# Sunnyside Coal Company

Re: NOV92-32-17-1 Failure To Maintain Diversions

PLATE 5-5

PLATE 5-5

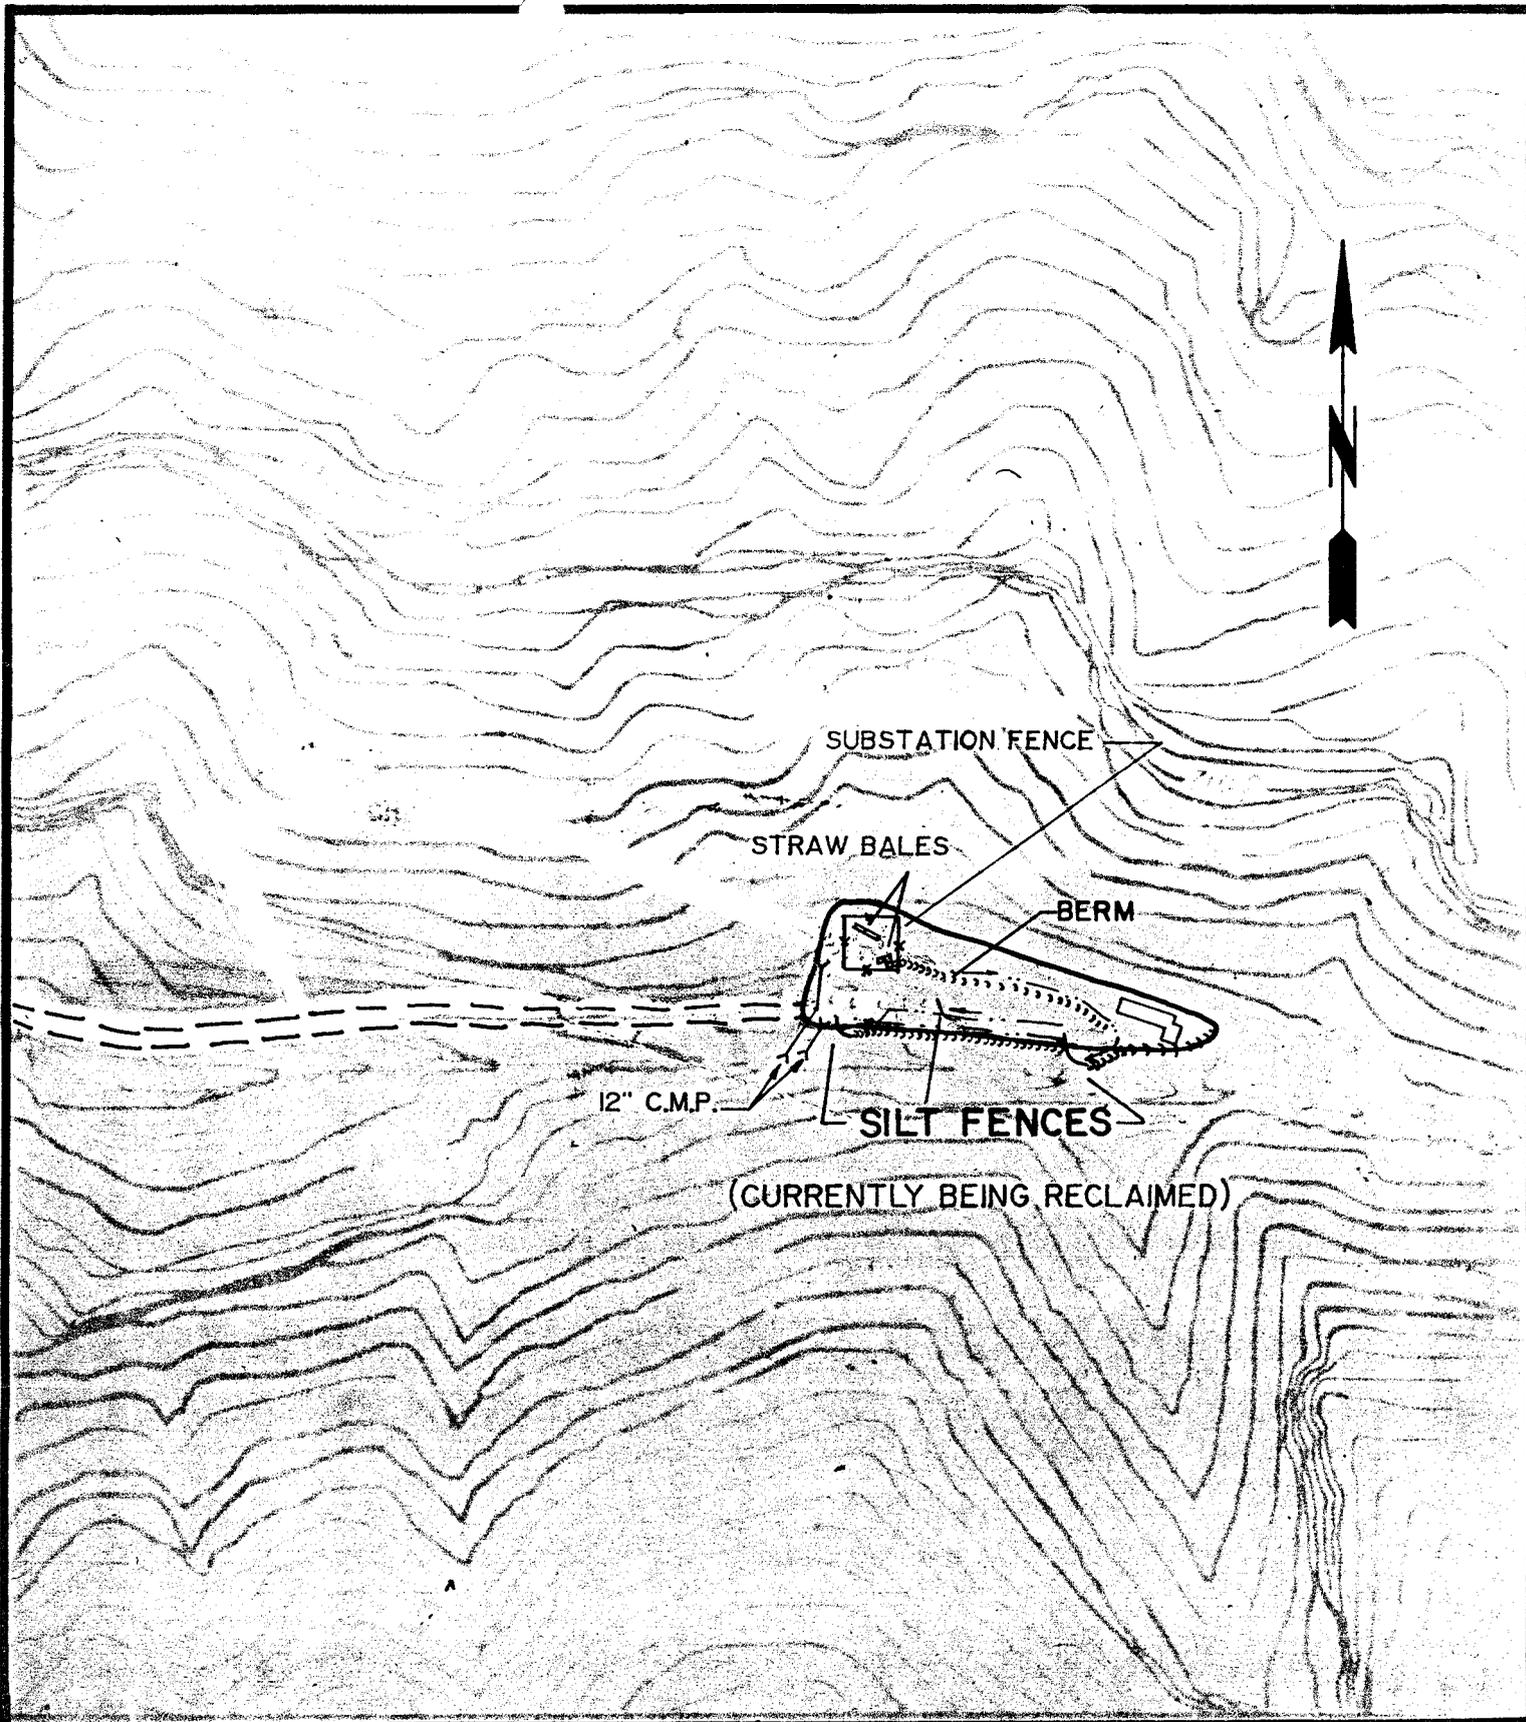
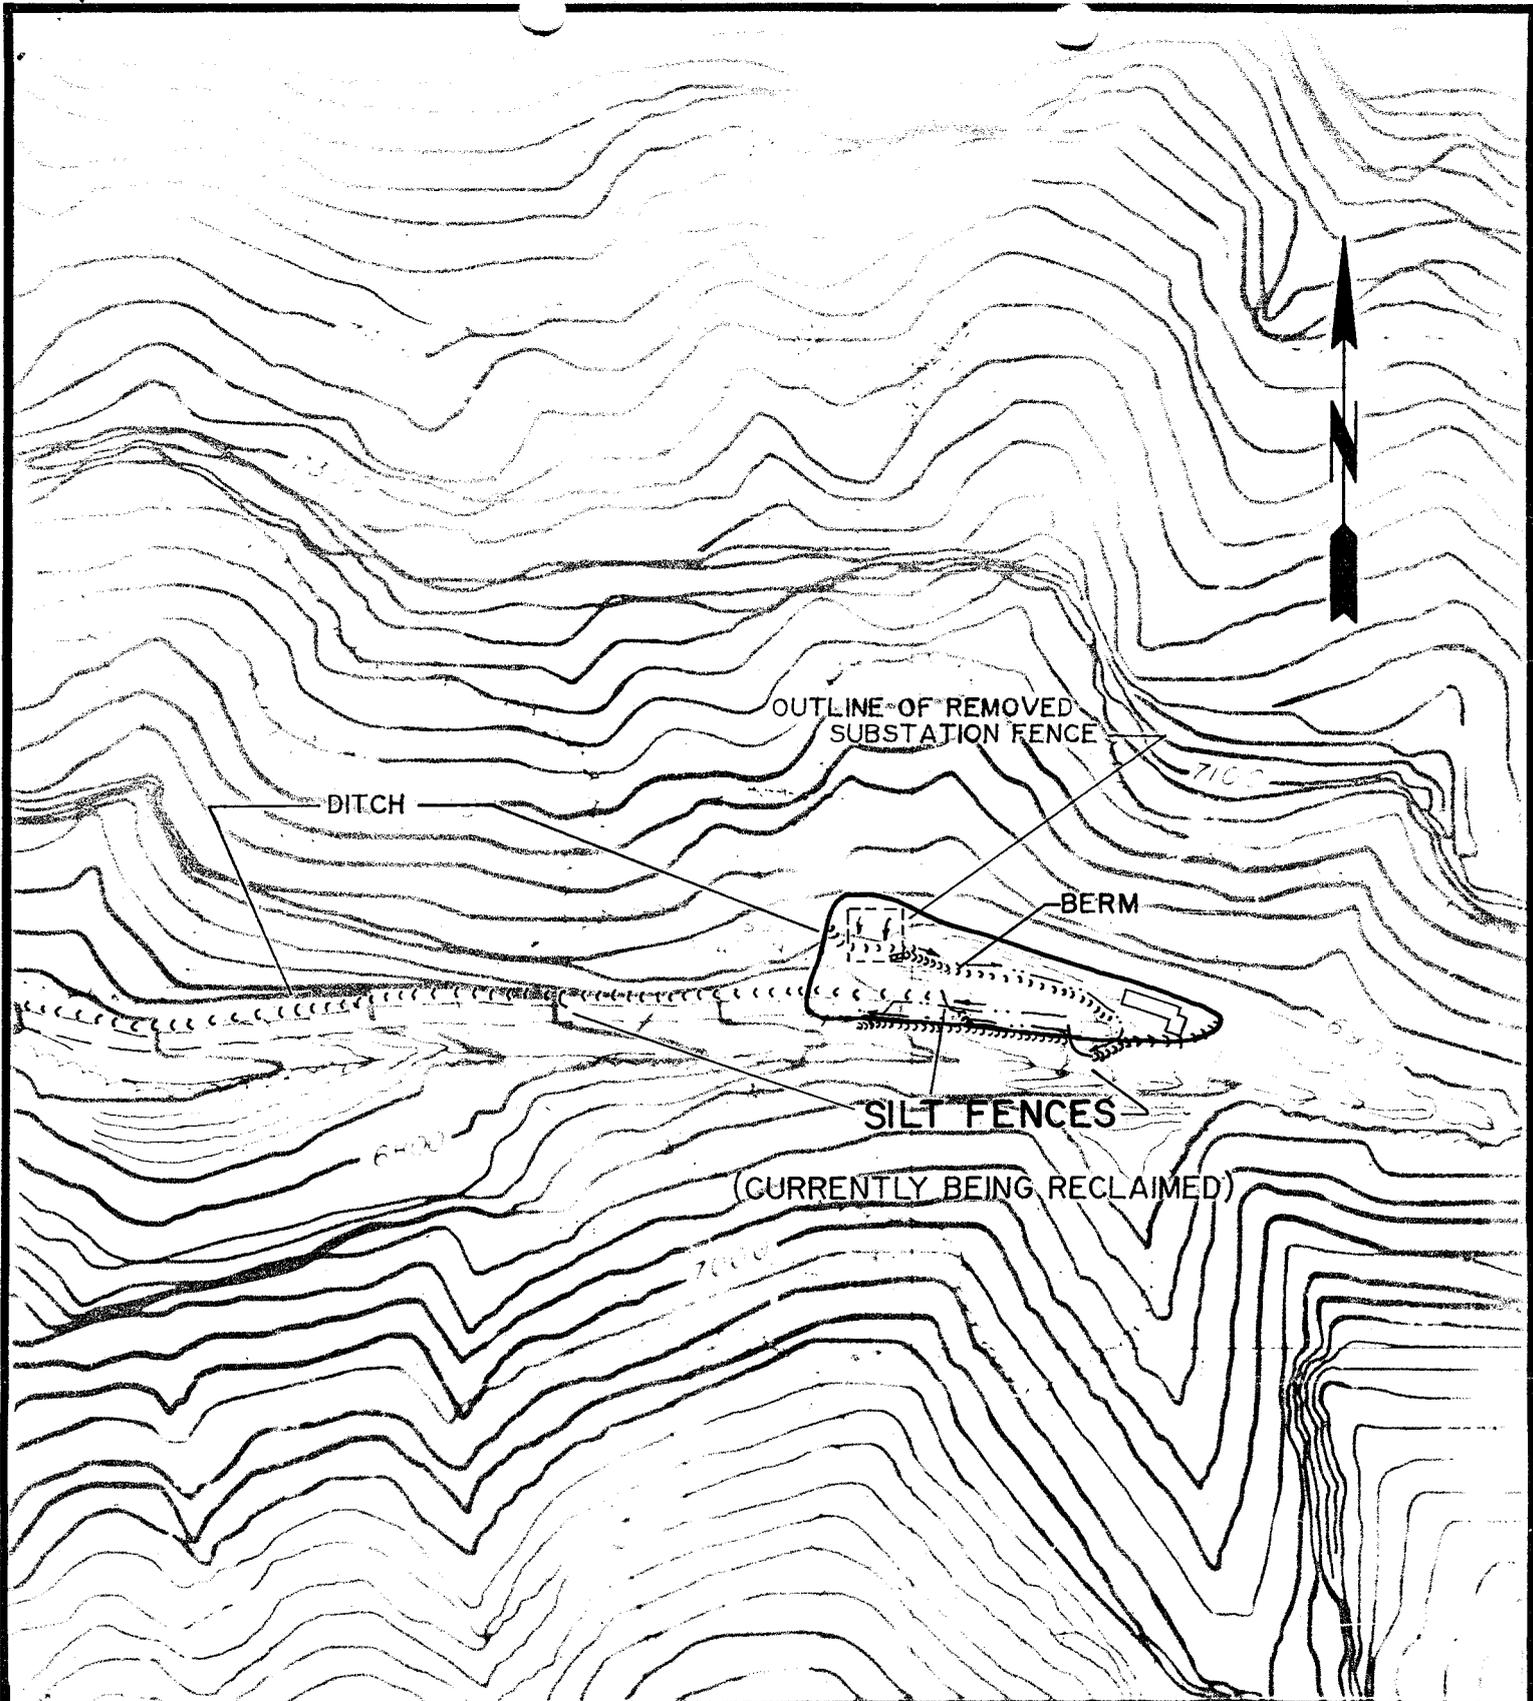
The abatement of the area at the Fan Canyon B.T.C.A. presents another problem. We used a backhoe to probe the area west of the old substation searching for the twelve-inch CMP inlet that supposedly drained the undisturbed area to the wash as shown on Plate 5-5, A5-0110. We had no success. The other twelve-inch CMP from the edge of the road to the wash was not located either.

Neither Ernest Monson nor Dale Andrews (who are long-time surface compliance personnel at this operation) remember either culvert. It is our belief that the culverts were never installed.

In order to provide temporary drainage for the disturbed area of the pad, Sunnyside Coal Company has removed two concrete pads inside the substation perimeter and cut a shallow ditch on an angle from the cliff wall on the west side of the old substation perimeter along the front of the pad and tied it into the berm which parallels the substation access road. All runoff would report to the silt fences below. We have also established a berm at the middle silt fence to the edge of the wash and redefined the ditch to the bottom fence.

I have also revised Plate 5-5, A5-0110, to Plate 5-5, A5-0110-R, making the necessary changes. These are enclosed.
